DS-K1T341A Series MinMoe Terminal

Release Notes (2022-04-09)

Device Model: DS-K1T341AM DS-K1T341AMF Naming Rule: M for M1 card, F for fingerprint	Firmware Version	ARM: ACS_641_AI3_EN_STD_V3.2.30_build220311 ACS_641_AI3_EN_NEU_V3.2.30_build220311
	SDK	Latest version
	iVMS-4200 Client Version	Latest version baseline

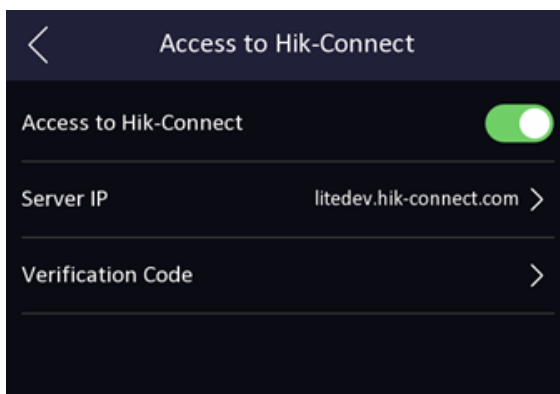
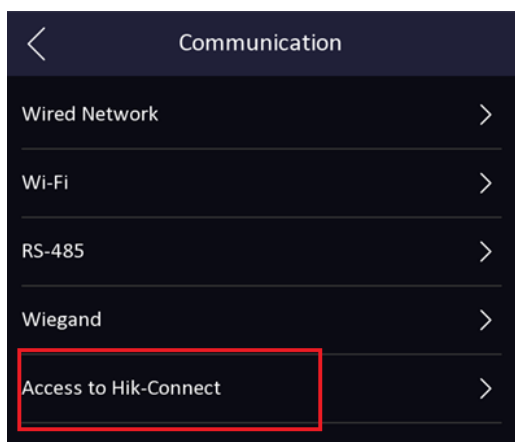
1. Add Hik-Connect menu in device UI Menu→Comm. The function is disabled in default.

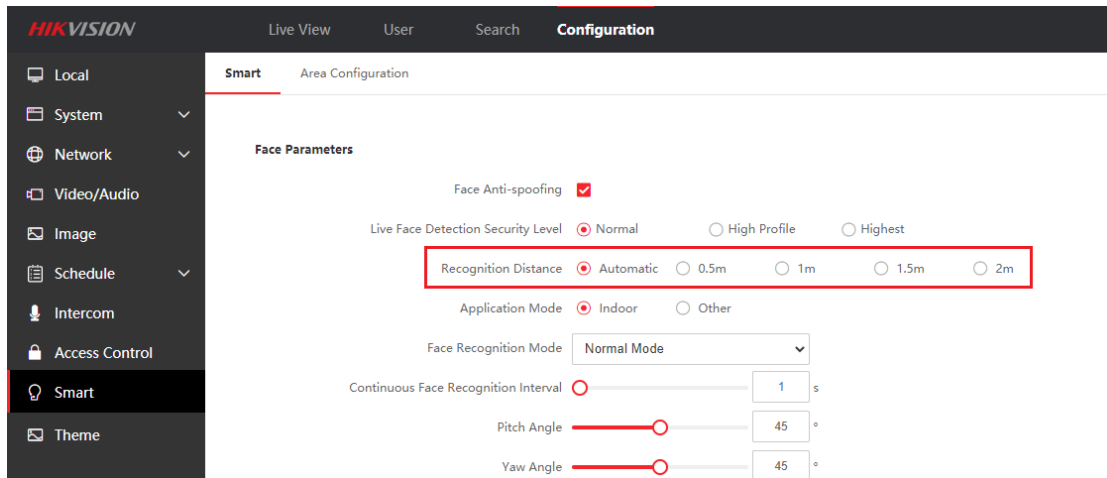
1. Optimize the wake-up distance of the device screen through the face, and the wake-up distance is consistent with the recognition distance
